Product Change Notification

Product Group: TC/Thursday July 30, 2026/PCN-TC-016-2026-REV-0

Enhanced T55/T56 multi anode D-case capacitor construction

T55 and T56 series case D – Old construction

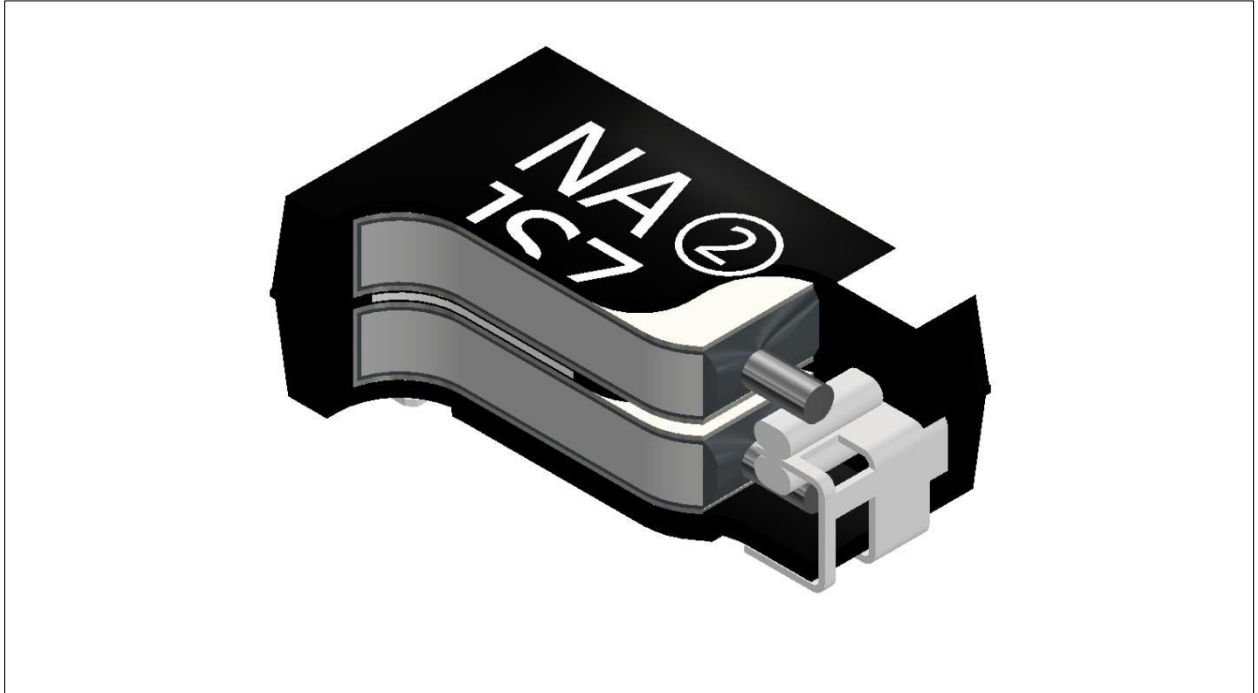
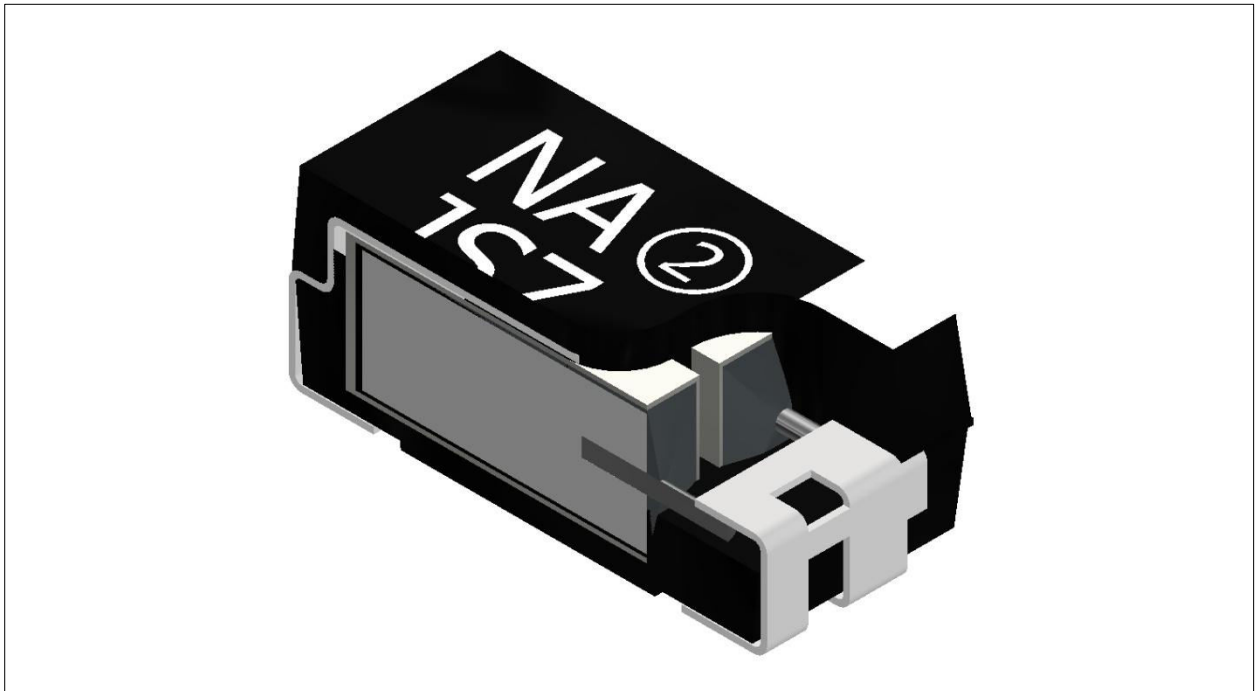
Description of Change: Redesigned dual anode architecture with optimized anode orientation changed from stacked to side-by-side.

Reason for Change: Side-by-side orientation of anodes provides direct connection to a lead frame, improved manufacturability and lower ESR values.

T55 and T56 series case D – New construction
